Access Compliance Report

Public Rights-of-Way

(Curb Ramps)

Intersection ID: 24455	Main Street: S_TRYON_ST	Cross Street: STEELE_CREEK_RD	Location: SE
ADA ID: 073E98951232	Ramp Type: Perp	Initial Pass/Fail: Fail	Overall Compliance: No
Severity Score: 21.25			
Codes/Mitigation Info/Possible Solution		Field Measurements/Component Compliance

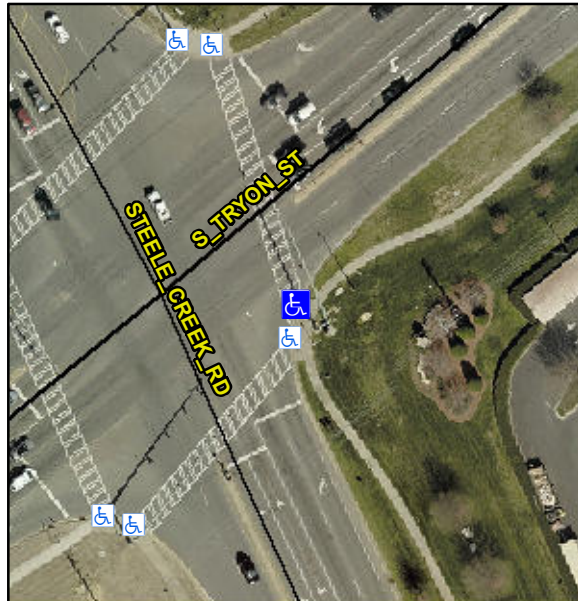
R304.5.1, R304.2.2

Compliance	Description	Data	Compliance	Description	Data
N/A	Ramp Length (in)	72.0	No	Ramp Slope (%)	9.0
No	Ramp Width (in)	47.0	Yes	Ramp XSlope (%)	1.9
N/A	Flare Type LT	N/A	N/A	Flare Type RT	N/A
N/A	Flare Slope LT (%)	N/A	N/A	Flare Slope RT (%)	N/A
N/A	Flare Traversable LT?	N/A	N/A	Flare Traversable RT?	N/A
N/A	Landing Length (in)	N/A	N/A	DWS Provided?	N/A
N/A	Landing Width (in)	N/A	N/A	DWS Contrast?	N/A
N/A	Landing Slope (%)	N/A	N/A	DWS Length (in)	N/A
N/A	Landing X Slope (%)	N/A	N/A	DWS Full Width?	N/A
N/A	Landing Curb? (Y/N)	N/A	N/A	DWS Offset (in)	N/A
N/A	Shared Landing?	N/A			
N/A	Gutter Ponding?	N/A	N/A	Gutter Slope (%)	N/A
N/A	Gutter Lip Ht (in)	N/A	N/A	Gutter X Slope (%)	N/A
N/A	Painted X Walk1?	Yes	N/A	Painted X Walk2?	N/A
	X Walk 1 Direction	To N		X Walk 2 Direction	N/A
N/A	X Walk 1 Width (in)	125.0	N/A	X Walk 2 Width (in)	N/A
	X Walk 1 Slope (%)	1.6		X Walk 2 Slope (%)	N/A
	X Walk 1 X Slope (%)	3.5		X Walk 2 X Slope (%)	N/A

N/A	Ramp inside XWalk1?	Yes	N/A	Ramp inside XWalk2?	N/A
	Road Slope (%)	N/A	N/A	Clear Space?	N/A
	Road X Slope (%)	N/A	N/A	Clear Space to XWalk (in)	N/A
N/A	Any Obstructions?	N/A	N/A	Storm Grate/Utility Hazard?	N/A
	Obstruction Type			Storm Grate/Utility Type	
		N/A			N/A
			Yes	Surface Condition? (G/P)	Good

Remove & Replace Entire Ramp.
